ARCHITECTURAL REVIEW COMMITTEE MEMORANDUM

DATE: MARCH 21, 2022 NEW BUSINESS

SUBJECT: MICHAEL BECKMAN, OWNER, REQUESTING A LAND USE PERMIT AND A WAIVER TO CONTINUE THE USE OF AN ENLARGED PARKLET WITH SHADE STRUCTURE LOCATED AT 800 NORTH PALM CANYON DRIVE, ZONE C-1, (CASE 21-091 LUP). (AP)

SITE PLAN

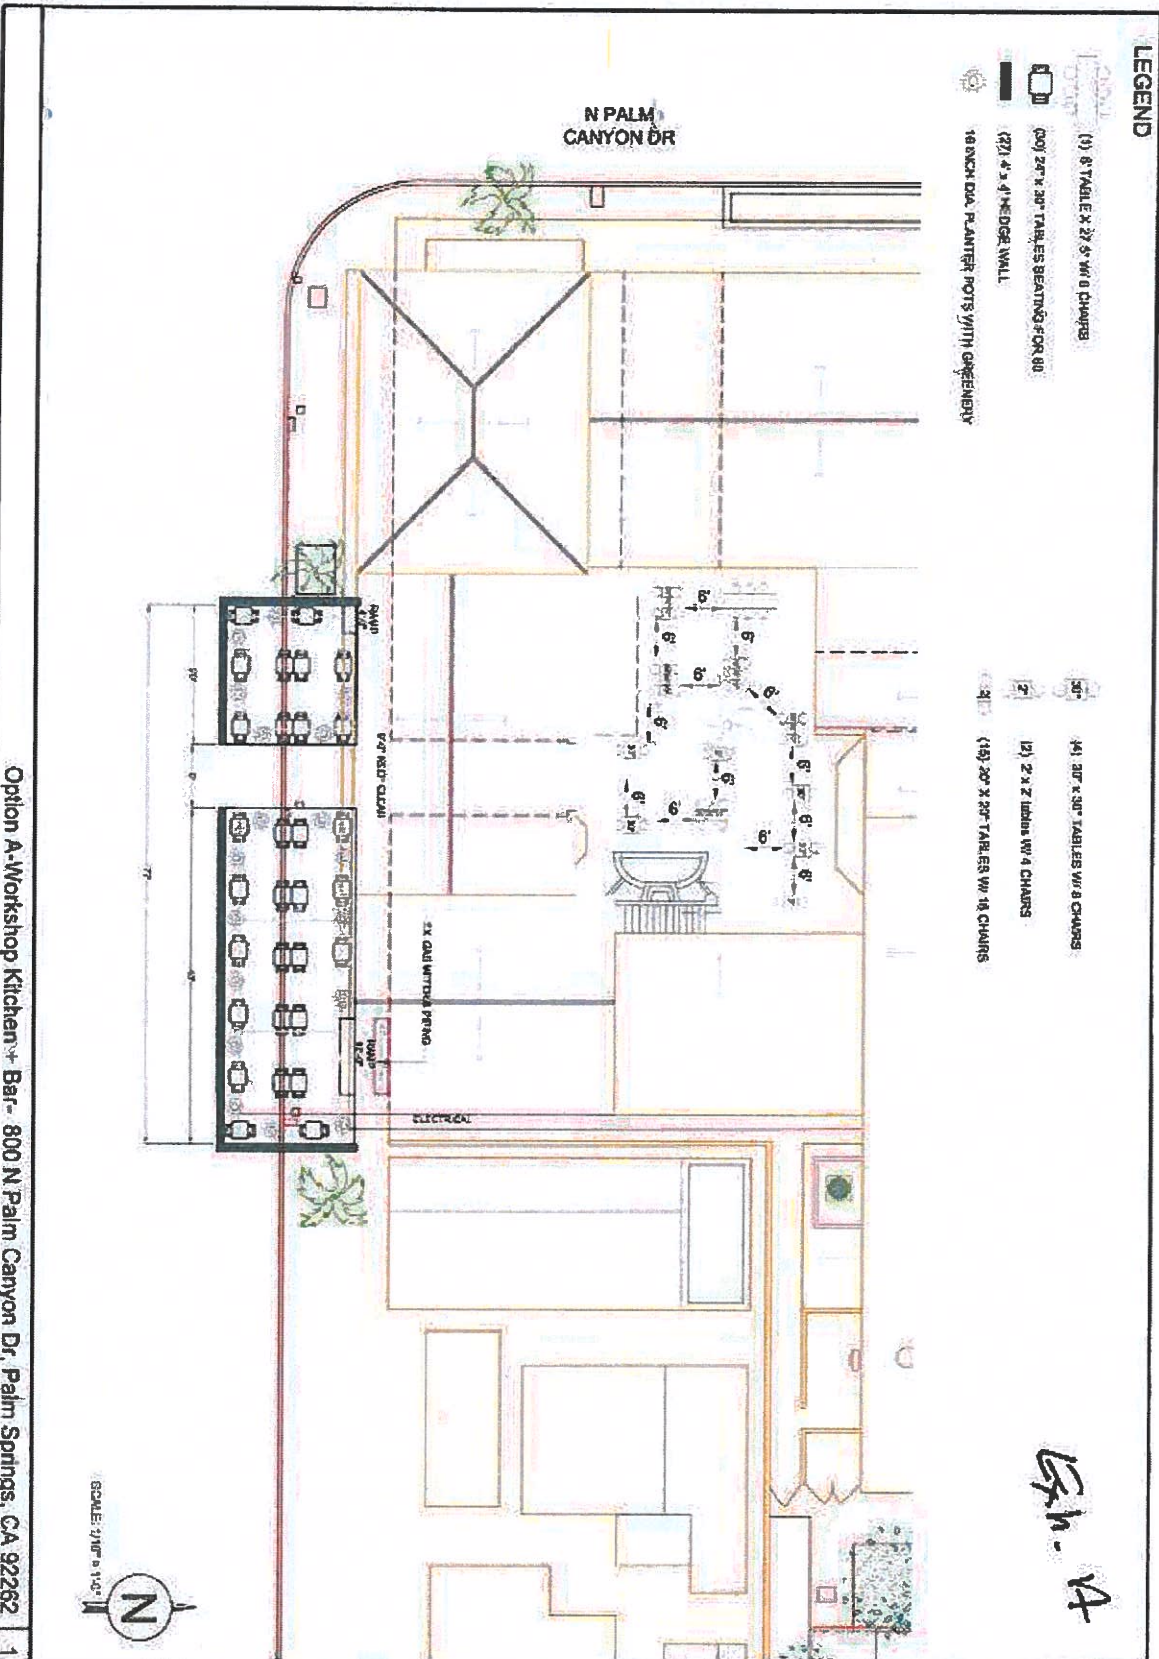
1. The parklet railing is painted white, which is not on the list of approved colors.
2. The parklet is not flush with the adjacent sidewalk.

That the Architectural Review Committee approve the application as submitted.
